Appendix I

Public Comments and Responses on Draft Integrated Document

I Public Comments and Responses on Draft Integrated Document

Figure I-1. WPCP South – Drying Beds

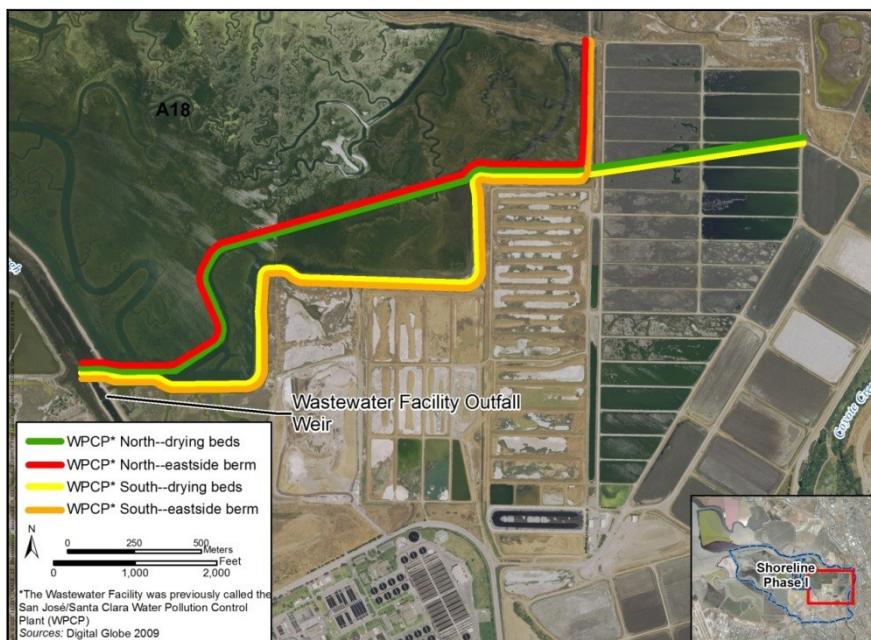
Multiple letters state that the Shoreline Study team prematurely dismissed a variation of the levee alignments that would move the last “leg” of the eastern-side of the Pond A18 levee from its northern terminus (shown in orange in Figure I-1 *Potential Wastewater Facility Segment Levee Alignments*) on the Coyote Creek Flood Protection levee, to a more eastern terminus (shown in green) on the Coyote Creek Flood Protection levee further upstream. In either terminus location, the Shoreline levee would tie into the Coyote Creek flood protection levee which is FEMA certified to provide 100-year fluvial flood protection.

The eastern terminus alignment was not carried forward as a feasible alternative for consideration in the draft EIR/EIS (referred to in this document as an Integrated Document as combined with the USACE Interim Feasibility Study) because the City of San Jose's current plan for the San Jose-Santa Clara Regional Wastewater Facility (Wastewater Facility) is to retain the existing sludge lagoons which currently occupy the area needed to implement an eastern terminus alignment. The City of San José adopted the Plant Master Plan (PMP) for the Wastewater Facility in November 2013. The PMP is a planning document to guide improvements at the plant for the next 30 years, including defining future treatment needs and designating future land use on plant lands. The PMP identified a tentative levee alignment which would allow the Wastewater Facility's continuous use of the sludge lagoons for the dewatering treatment process. The eastern terminus alignment would require the removal of some of the lagoons. In preparing the response to this comment, the Shoreline team re-engaged the City of San José staff to solicit additional information about their operations and long-term preferences. The City of San Jose is currently conducting an evaluation of the odor impacts of the Wastewater Facility's operations, including the sludge lagoons, on the surrounding community and the feasibility of using other waste processing technology. Once the study is concluded, the City will be able to analyze its future operations and possibly determine whether or not it will continue to use the sludge lagoons.

Figure I-2. Potential Artesian Slough Crossing Options

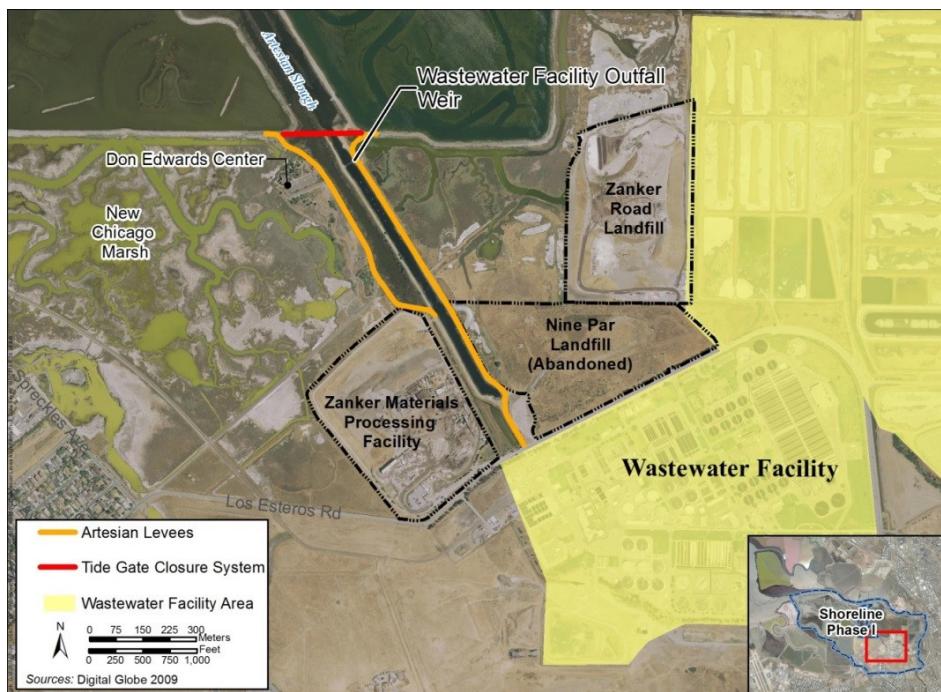
- Whether closing flood gates downstream of the Wastewater Facility's effluent discharge is feasible
- Impacts to the Wastewater Facility's treatment process
- Conversion of aquatic habitat in Artesian Slough due to freshwater discharges from the Wastewater Facility or adding an obstruction in the slough that may alter the salinity
- Direct fill of Artesian Slough for the tide gate.

As stated in the draft Integrated Document, the measure that includes constructing levees up either side of Artesian Slough to high ground was not carried forward for further analysis because “it is less economically efficient than the tide gate measure and did not provide any additional advantages relative to the other criteria.” Additional analysis was conducted on the alternative to extend levees down both sides of Artesian Slough (as depicted in Figure I-2 *Potential Artesian Slough Crossing Options*) that was not included in the draft Integrated Document.

Figure S-1. South San Francisco Bay Shoreline Interim Feasibility Study Areas

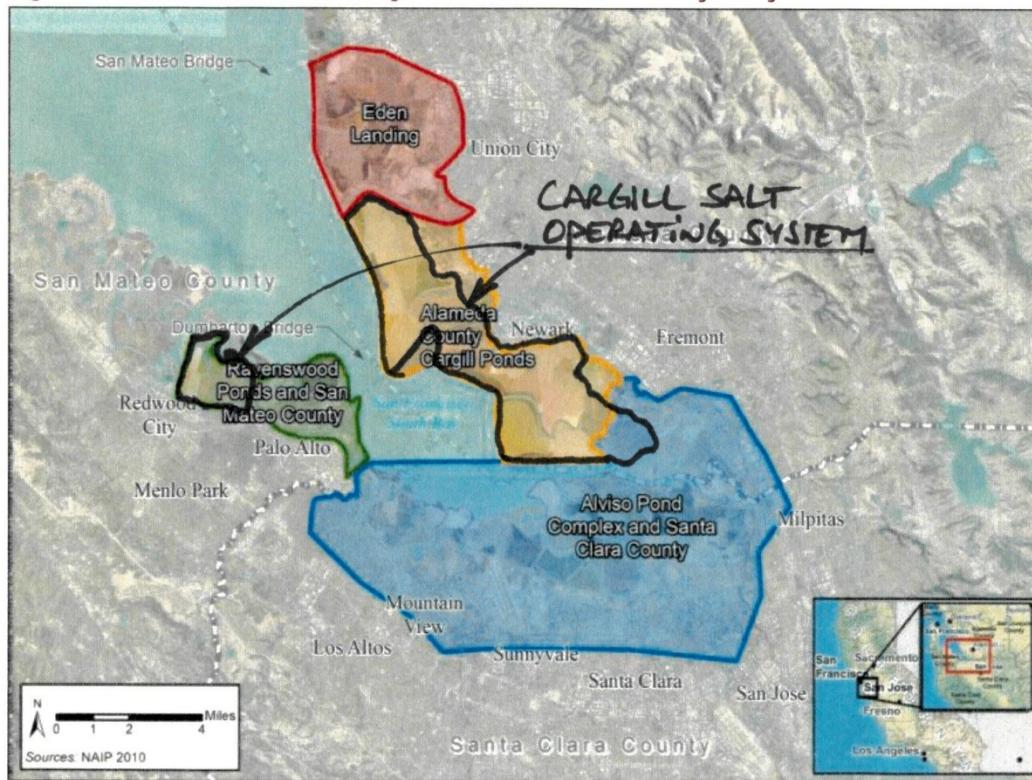
1. Figure S-1. South San Francisco Bay Shoreline Interim Feasibility Study Areas

ID	Issue Text	Response Text
040(CG-1)	<p>Figure S-1. South San Francisco Bay Shoreline Interim Feasibility Study Areas. This figure needs both a change in nomenclature as well as a line-shading adjustment. The border around the property labeled "Alameda County Cargill Ponds" is inaccurate. It fails to include our operating salt ponds 4 & 5, which are currently shaded blue and shown as part of the "Alviso Pond Complex and Santa Clara County". The orange shaded area also includes EBRPD's Coyote Hills - this needs to be removed from the map. Lastly, Cargill's Redwood City Plant Site needs to be distinguished from the "Ravenswood Ponds and San Mateo County". All of Cargill's property should be labeled "Cargill Salt Operating System". I have attached an edited map as Exhibit 1 for your reference.</p>	<p>Thank you for clarifying the boundaries of the individual feasibility study areas and the Cargill Salt operating system ponds. The suggested revisions to the Figure (now Figure 1.5.1) has been made per the edited map provided as an attachment to your letter. The Executive Summary was shortened and the Figure no longer appears there.</p>

EXHIBIT 3**HDR***Draft Integrated Document - Chapter 1.0***Figure 1.4-1. South San Francisco Bay Shoreline Interim Feasibility Study Areas**

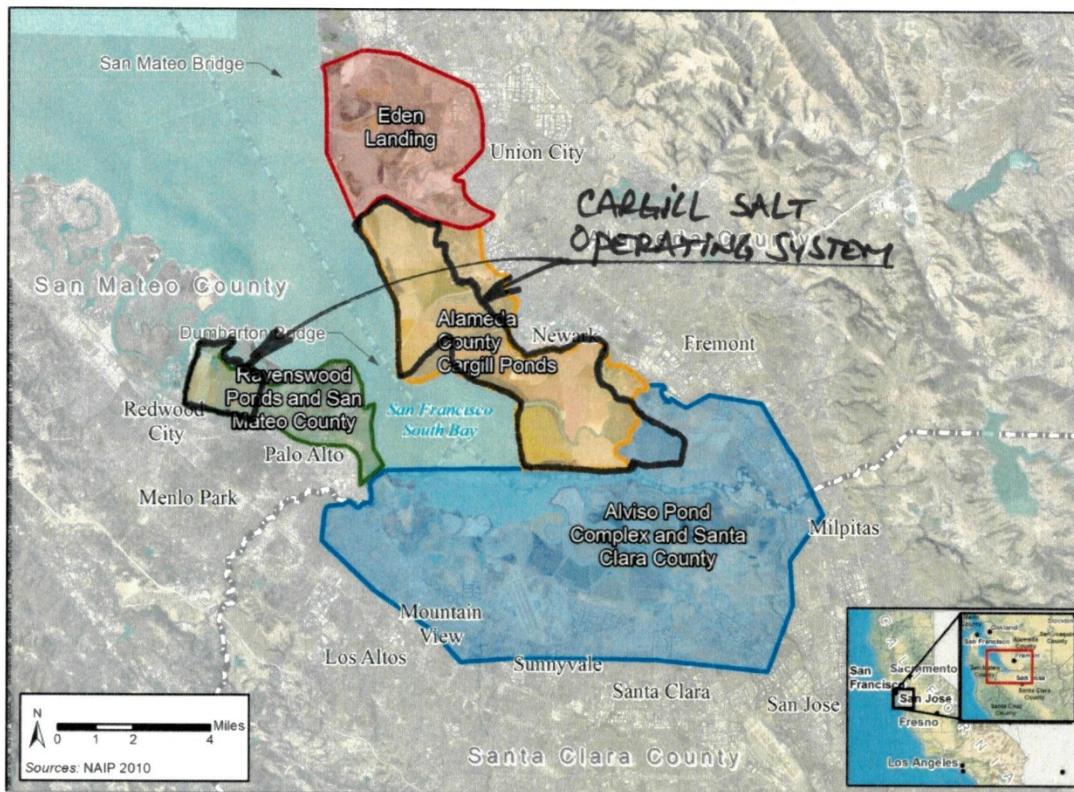
3. Figure 1.4-1. South San Francisco Bay Shoreline Interim Feasibility Study Areas

This is the same figure as Figure S-1. Please see comment #1 for details. I have attached an edited copy of this page as Exhibit 3 for your reference.

Figure 4.4-2. Estimated Bathymetry at Year 50 (2067) Based on the Modeling and Analysis by Brown (2010)

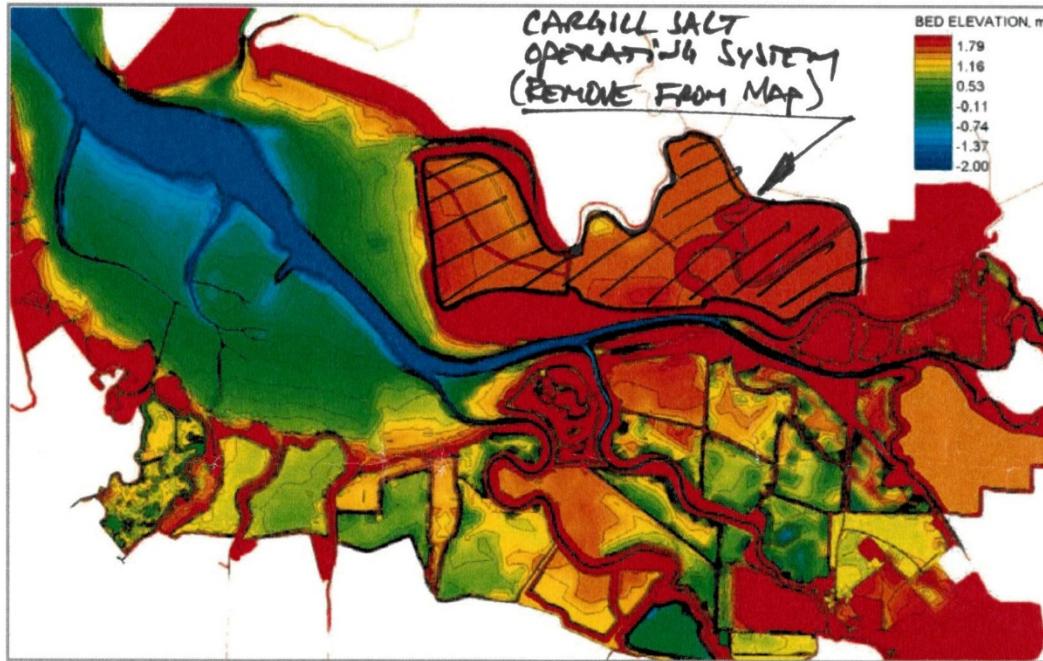
4. Figure 4.4-2 Estimated Bathymetry at Year 50 (2067) Based on the Modeling and Analysis by Brown (2010)

This figure shows an estimated bathymetry at year 50 in Cargill's operating ponds 1, 2, 3, 4, 5 & 6. Since this is outside the study area and within Cargill's continue operating ponds, please remove this from the map. It erroneously shows a bathymetric change in Cargill's operating ponds as if they were being subject to tidal action – which they are not, nor are they planned to be. Please see the attached edited page as Exhibit 4 for your reference.

040(CG-4)	<p>Figure 4.4-2 Estimated Bathymetry at Year 50 (2067) Based on the Modeling and Analysis by Brown (2010) This figure shows an estimated bathymetry at year 50 in Cargill's operating ponds 1,2,3,4,5 & 6. Since this is outside the study area and within Cargill's continue operating ponds, please remove this from the map. It erroneously shows a bathymetric change in Cargill's operating ponds as if they were being subject to tidal action - which they are not, nor are they planned to be. Please see the attached edited page as Exhibit 4 for your reference.</p>	<p>Thank you for clarifying the boundaries for the estimated bathymetry at year 50 (Figure 4.4-2). The referenced ponds have been removed from the figure and the bathymetric change has been limited to those areas in the study area that will be subject to tidal action.</p>
